EVERSTEAD  
SHOP DRAWINGS/SUBMITTAL REVIEW

DESCRIPTION	SUMMIT HOMES - HAWTHORN RIDGE #177- 2ND LVL
JOB ADDRESS	1637 SW ARBORWAY TERRACE
CITY	LEE'S SUMMIT, MO
DESIGNER	TODD W MOORE
DATE	9/7/2022

## ROOF TRUSS LAYOUT

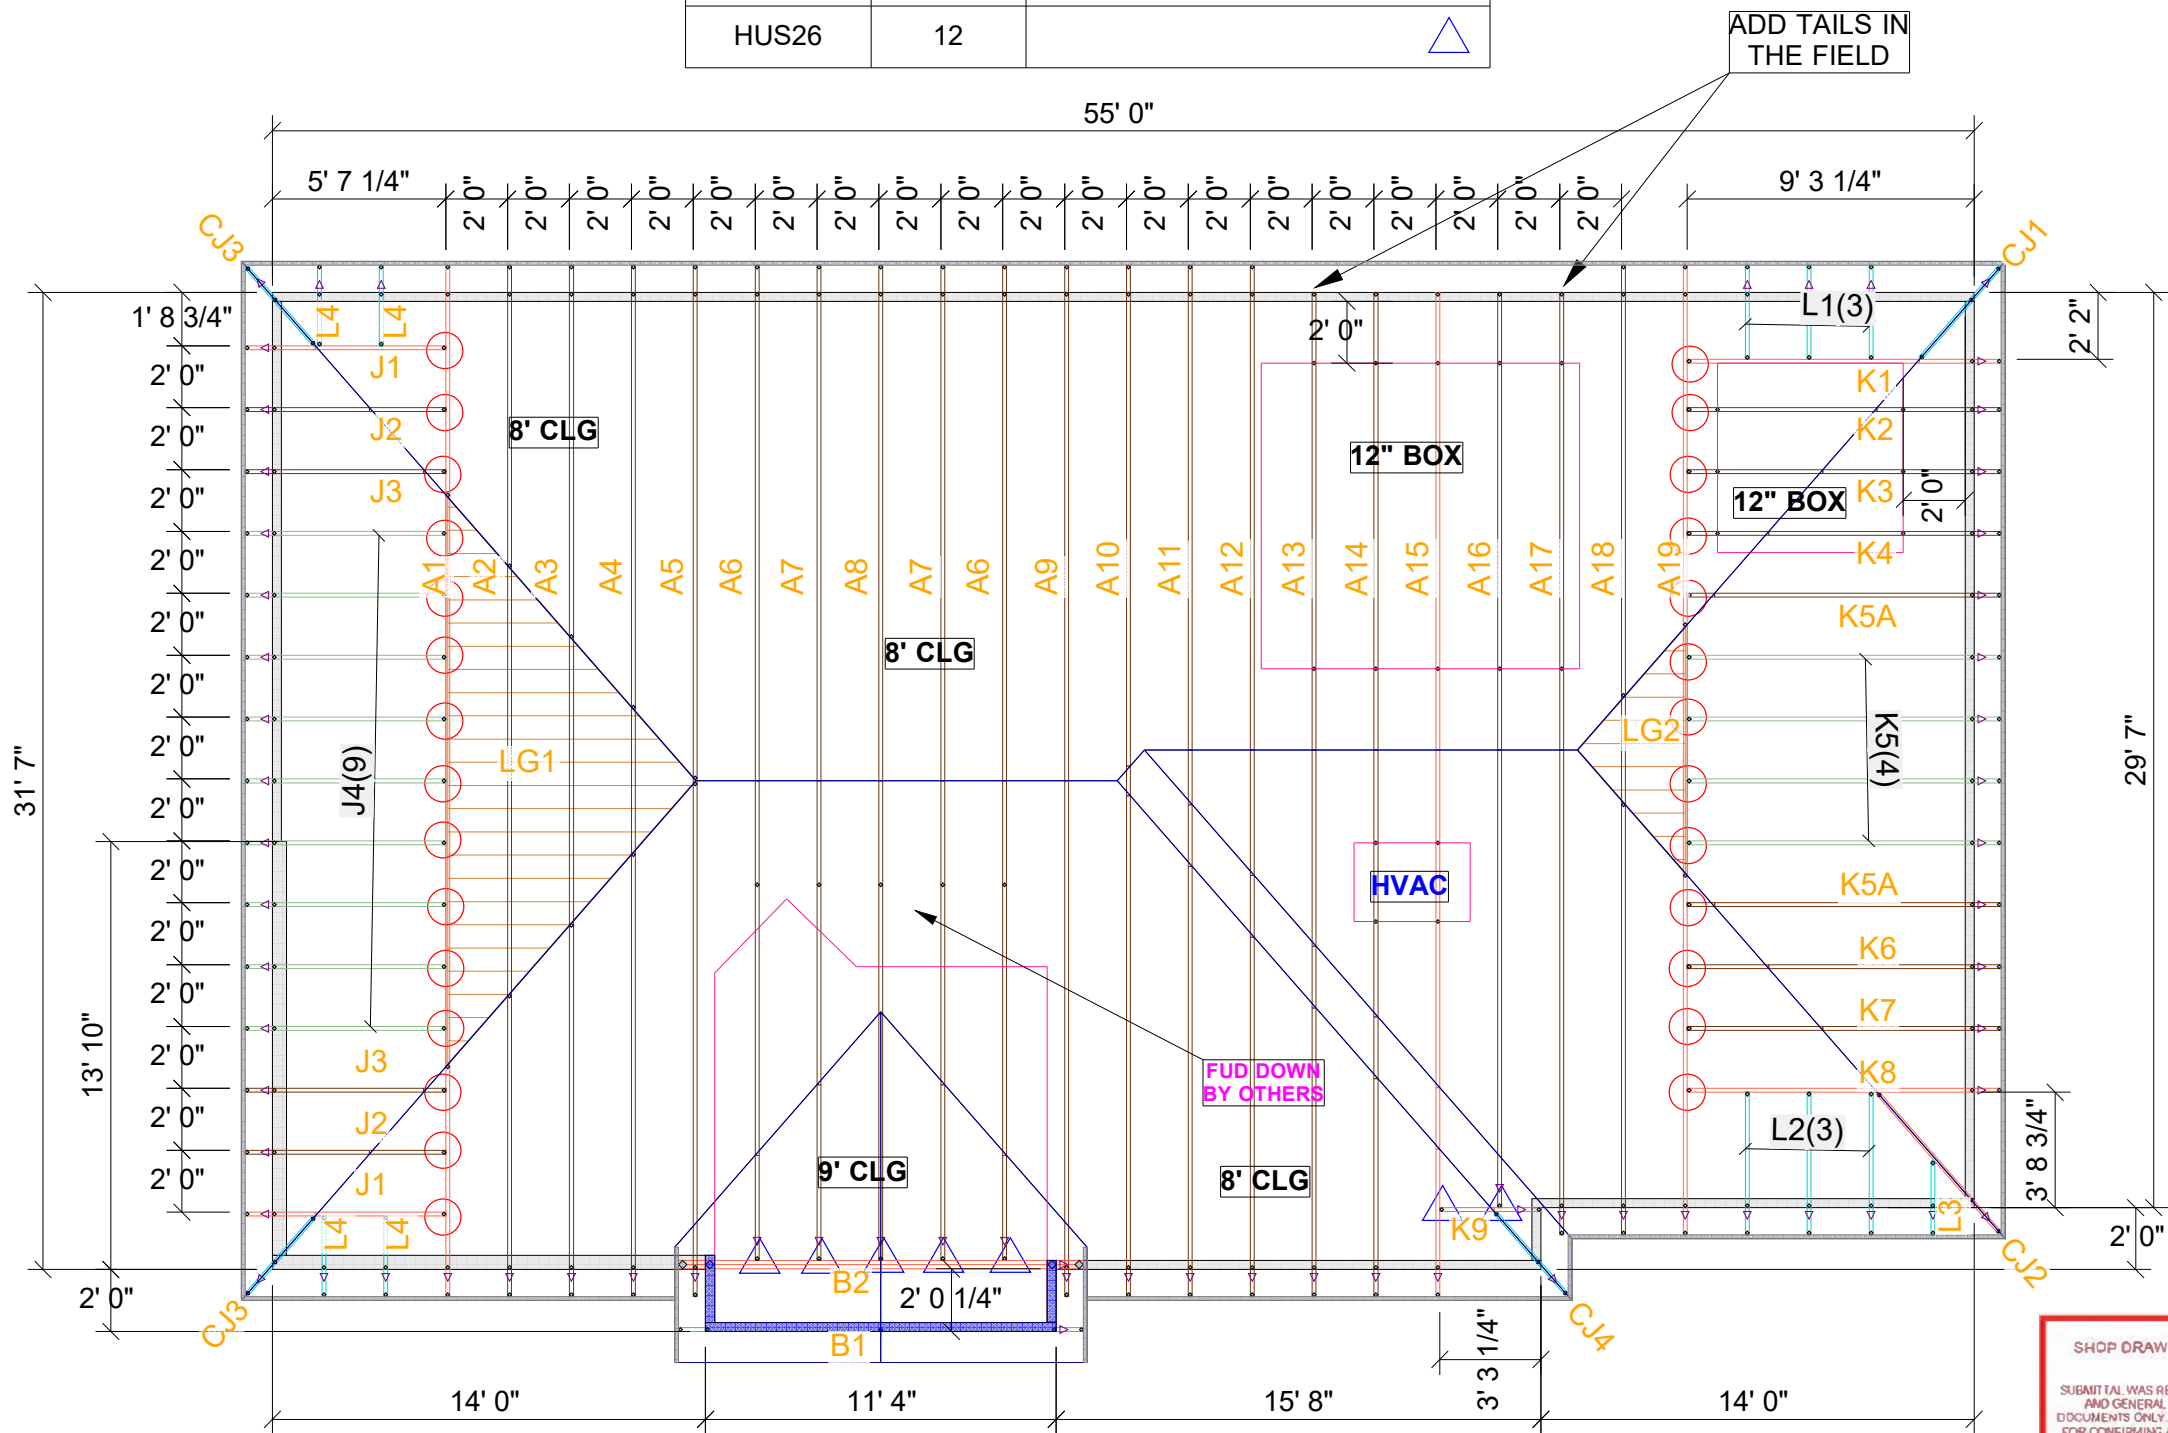
SUBMITTAL WAS REVIEWED FOR DESIGN CONFORMITY  
AND GENERAL CONFORMANCE TO CONTRACT  
DOCUMENTS ONLY. THE CONTRACTOR IS RESPONSIBLE  
FOR CONFIRMING AND CORRELATING DIMENSIONS AT  
JOBSITE FOR TOLERANCE, CLEARANCE, QUANTITIES,  
FABRICATION, COORDINATION OF HIS OR HER WORK  
WITH OTHER TRADES, AND FULL COMPLIANCE WITH  
CONTRACT DOCUMENTS.

APPROVED
